ORIGINATION FORM

Proposed Revisions to a Standard Plans Index
(Please provide all information — Incomplete forms will be returned)

Index Number: 715-001
Sheet Number (s): 1 OF 3
Index Title: Conventional Lighting

Sheet 1: Changed fuse holder slug (blank) requirement from solid copper to manufacturer's suggested in three drawing locations.

WIRING DIAGRAM

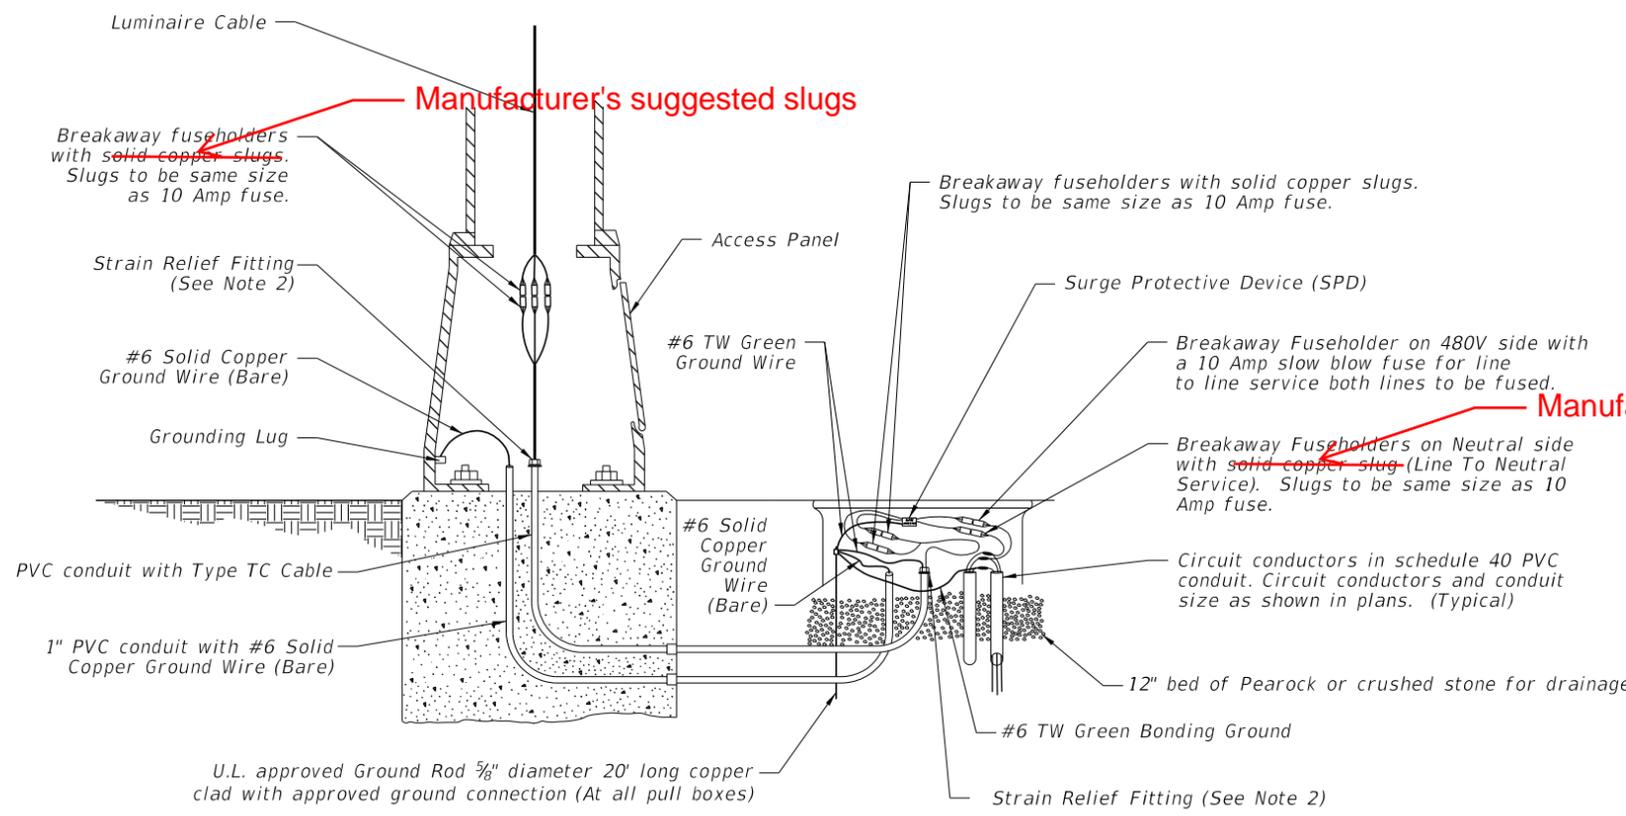
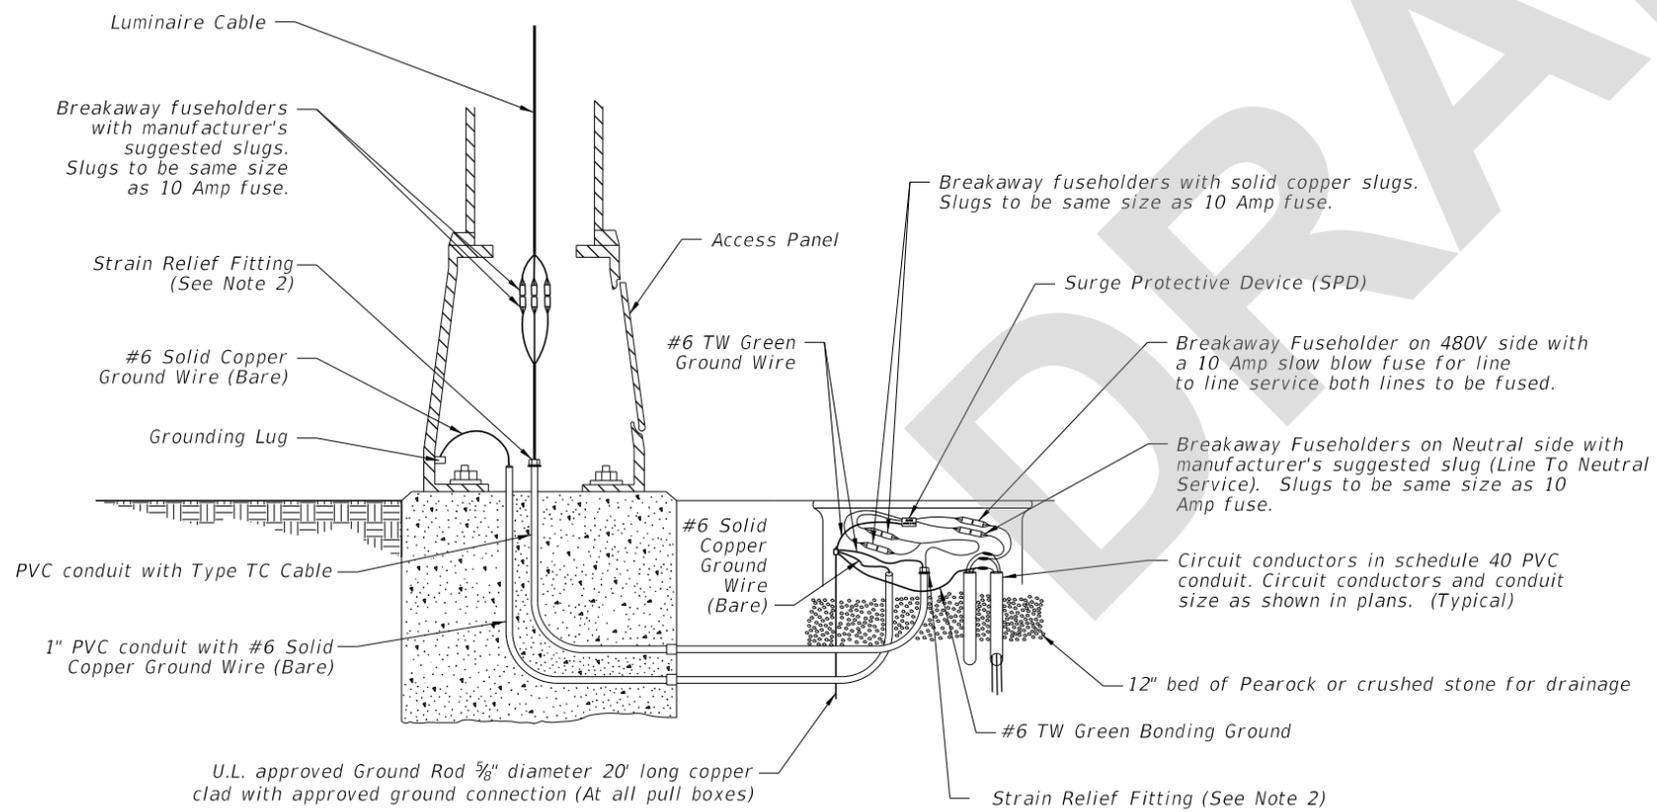
Manufacturer's suggested slug

Industry advised that solid copper slug requirement is impractical and uncommon. Specification 992 is being revised to require the fuse holder manufacturer's suggested slug of copper equivalent (manufacturer generally responsible for performance of their product). This Standards change reflects the Specifications change.

METAL POLE WIRING DETAIL

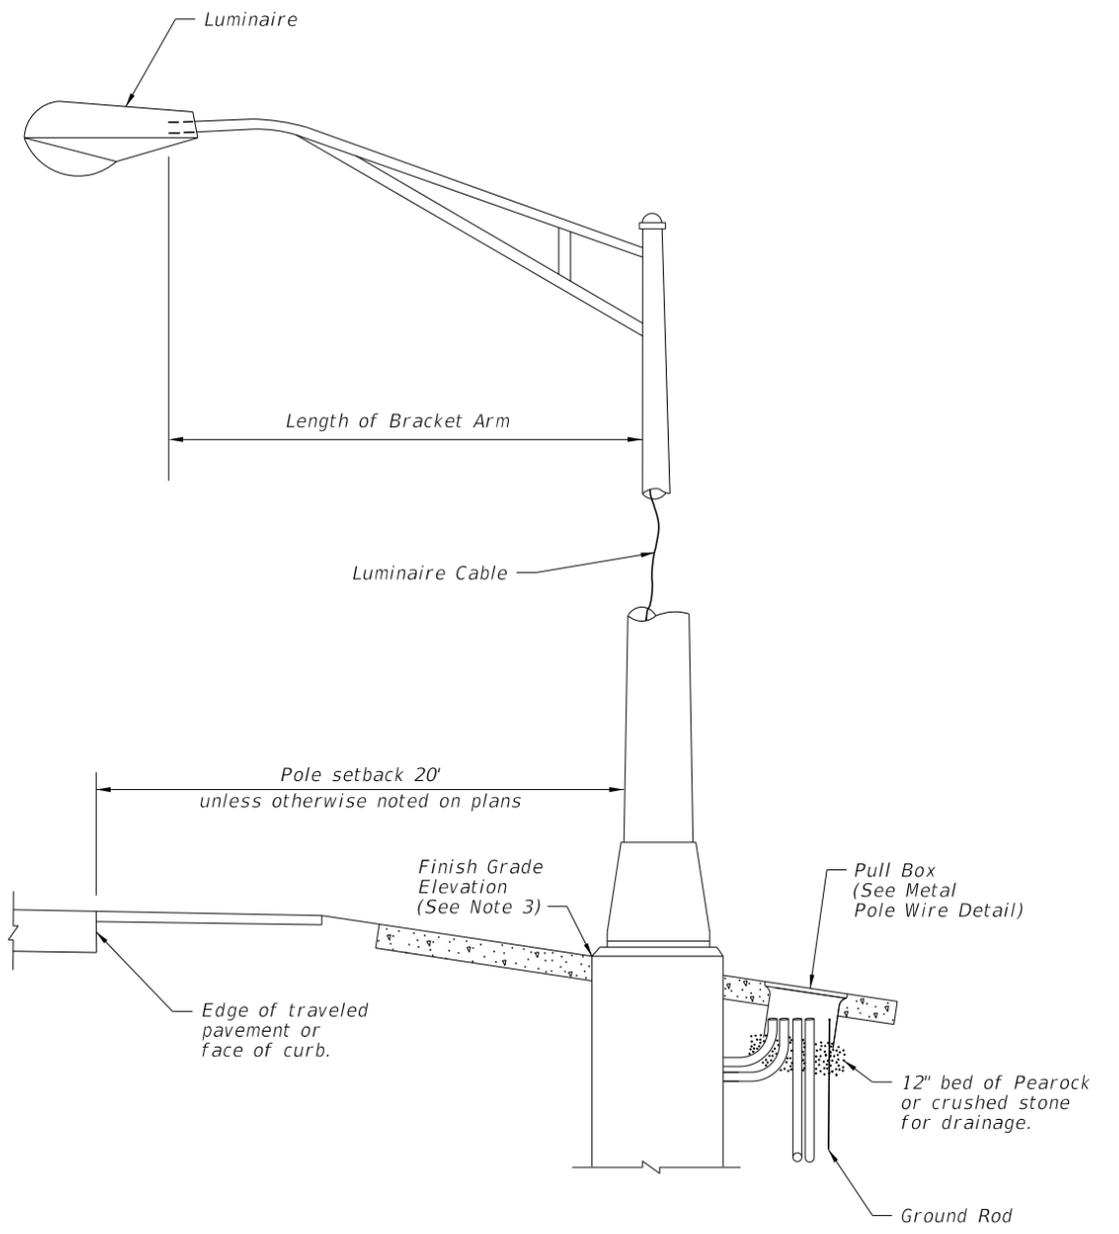
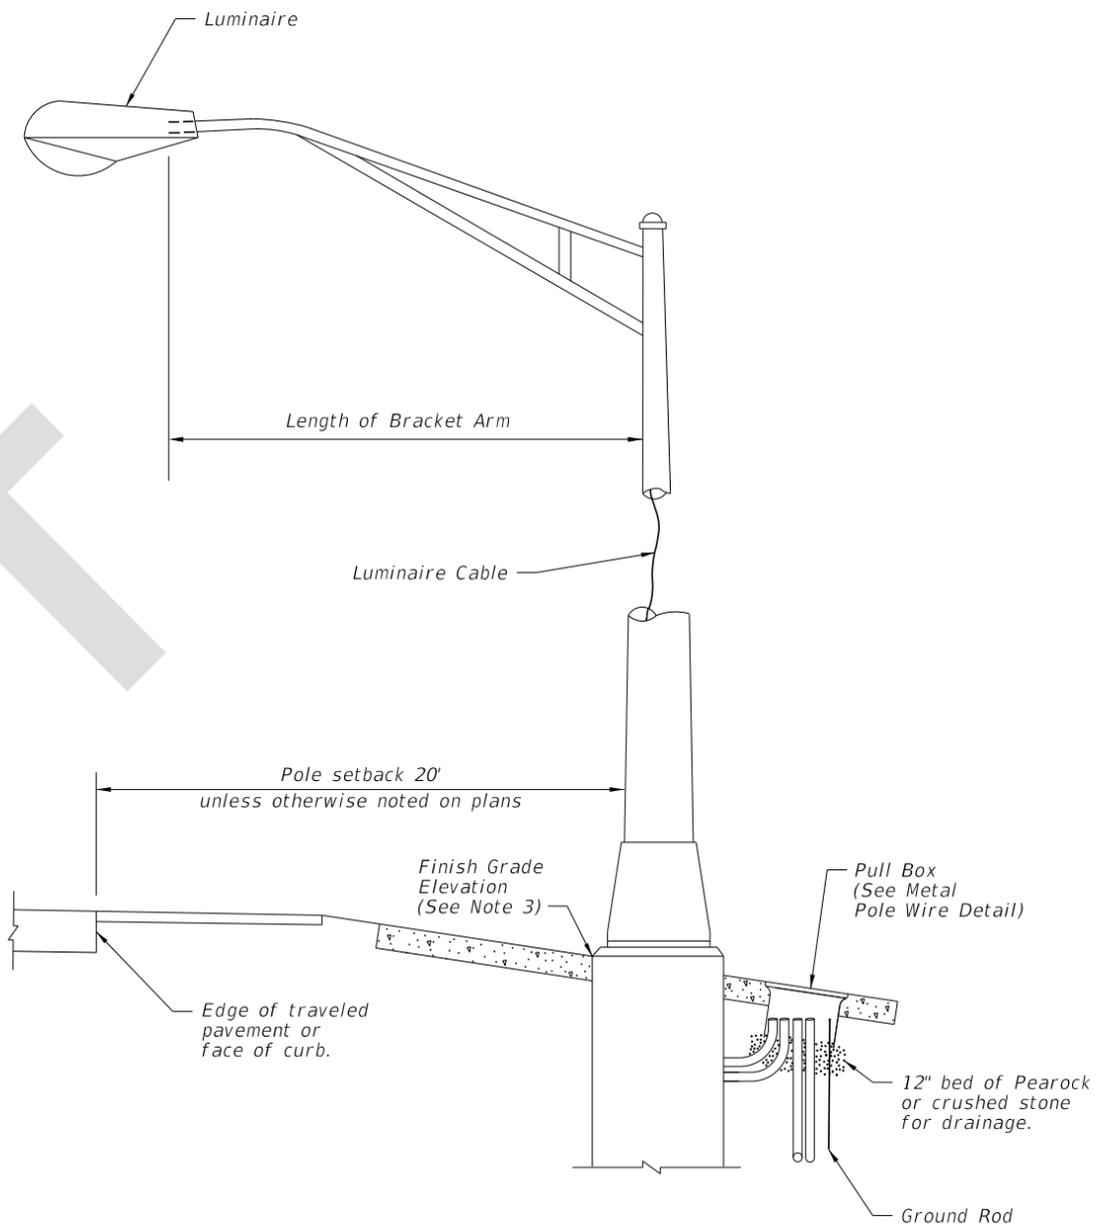
Manufacturer's suggested slugs

Manufacturer's suggested slug
